SERVICE INFO

Design change affecting tensioning pulley 531 0779 10

531 0779 10

Image 1: Front view of the previous model

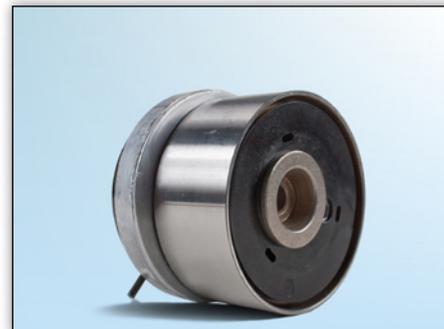
Due to the constant development of our products, the design of tensioning pulley 531 0779 10 has been changed. The Service Information sheet shows the visual differences between the two designs (see Images 1 to 4).

Please use a 6-mm hexagon allen key to turn the cam and tension the toothed belt with modified tensioning pulley.

Both tensioning pulleys meet the technical specifications and can be used without restrictions on the specified vehicles.
